February 14, 2022

Subject: Technical Assistance Provided
Community Within the Corridor – East Block
2748 N 32nd Street, Milwaukee, WI 53210
BRRTS #: 02-41-263675, FID #: 241025400

Subject: Review of Remedial Action Design Report
Community Within the Corridor – East Block
2748 N 32nd Street, Milwaukee, WI 53208
BRRTS #: 02-41-263675, FID #: 241025400

Subject: Review of Updated Remedial Action Design Report
Community Within the Corridor – East Block
2748 N 32nd Street, Milwaukee, WI 53208
BRRTS #: 02-41-263675, FID #: 241025400

FIGURE 1

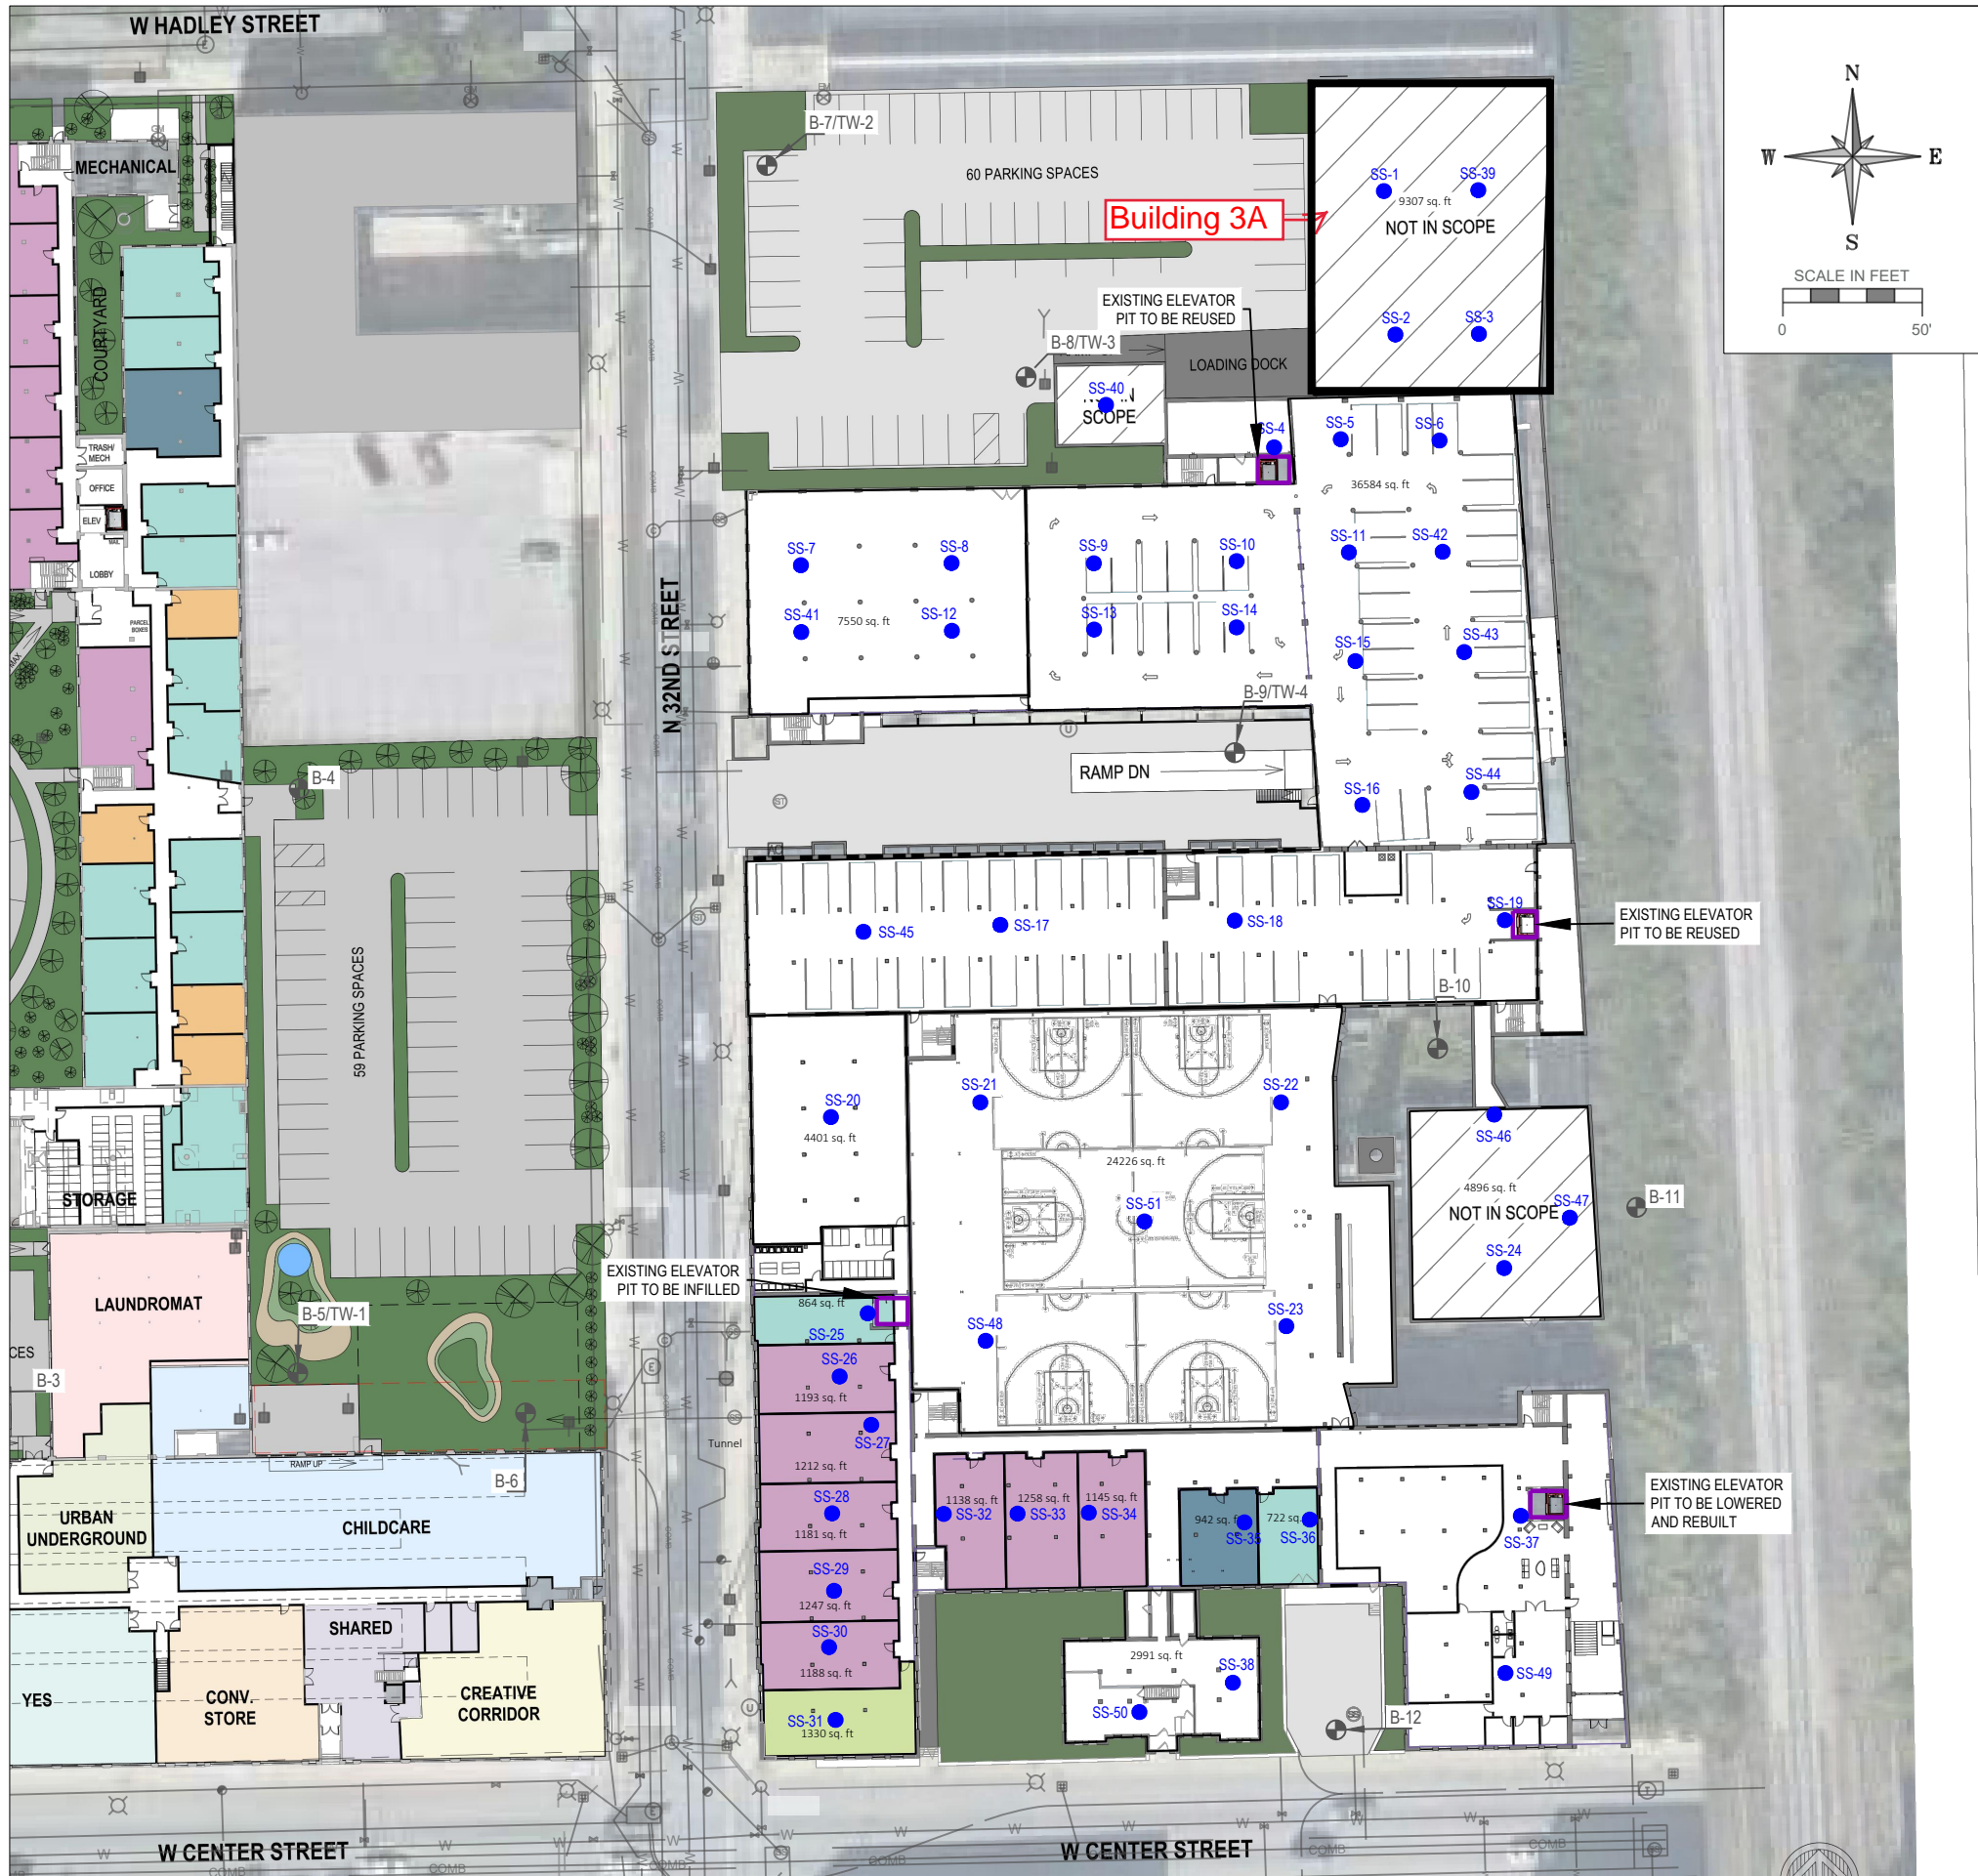
- I. In the Report, K. Singh indicates that there are no large commercial/industrial vapor risk screening level (VRSL) exceedances in Building 3A. This statement is not accurate. As documented in tables and figures presented in the Report, large commercial/industrial VRSL exceedances exist at sample locations SS-2 and SS-39 in Building 3A. These exceedances must be considered when evaluating the effectiveness of the system.

- II. Hexane greater than its applicable large commercial/industrial VRSL was identified at sample location SS-39. Considering the potentially explosive properties of hexane, evaluate the need for spark resistant fans in Building 3A and other buildings on site, as may be applicable. Update the fan type as may be necessary.

FIGURE 6B

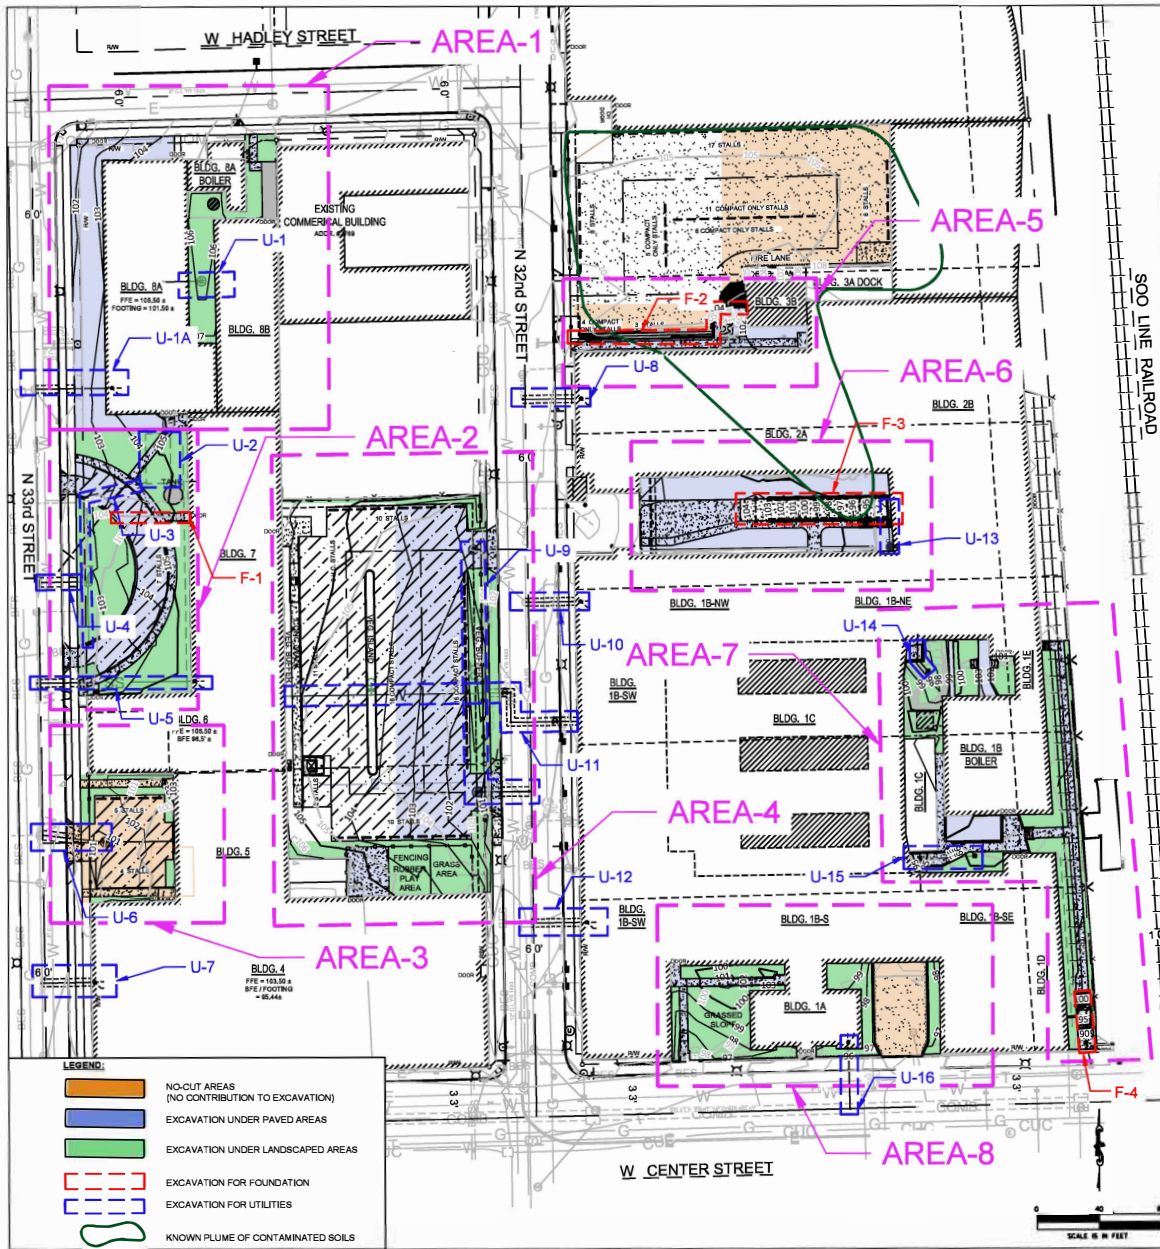
- Soil excavation in the areas, outlined on Figure 6B (attached) from the Report;
- Implementation of engineered barriers to limit direct contact and groundwater infiltration will consist of the building, pavement, soil, and vapor barriers;
- Groundwater remediation through natural attenuation.

- 1. The Report indicates that there will be four main areas of excavation at the site which will focus on the parking garage area and the utilities beneath the building. Considering these excavations are to facilitate redevelopment and were not specifically designed or remediation,
